Plan Commission

Agenda

Monday, September 28, 2015	7:00 PM	De Pere City Hall Council Chambers
-----------------------------------	----------------	---

Item 3B: Review the Site Plan Application for 102 N. Broadway for a four story, 39,600 sq ft building, parcel ED-844. Applicant: Broadway Investment Partners LLC.

CURB REMOVAL DETAIL

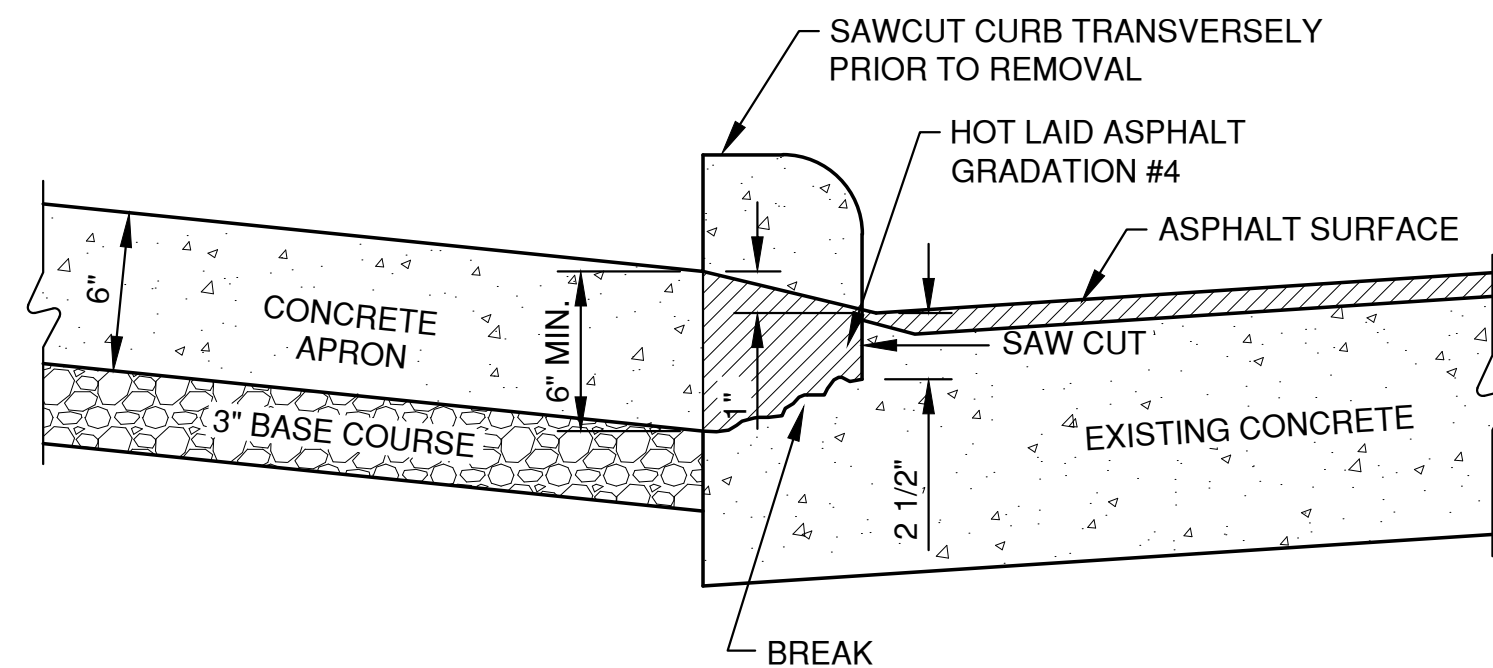
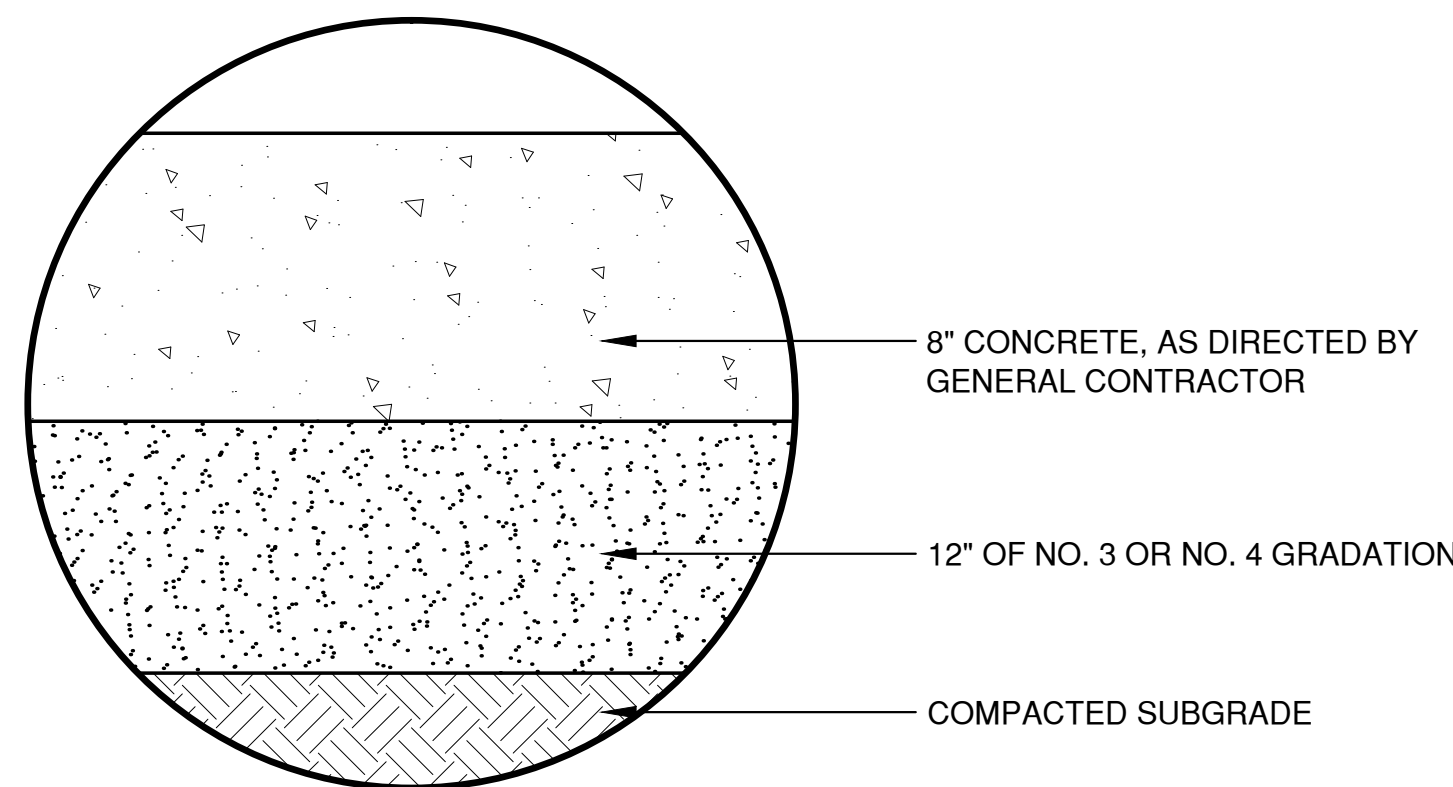
6. Curb cut permits are required for new driveways. Remove the curb removal details shown on sheet 4 of the plan. New curb will be required along the alley that complies with the City of De Pere Construction Specifications. Show the width of the driveway flares on the plan.
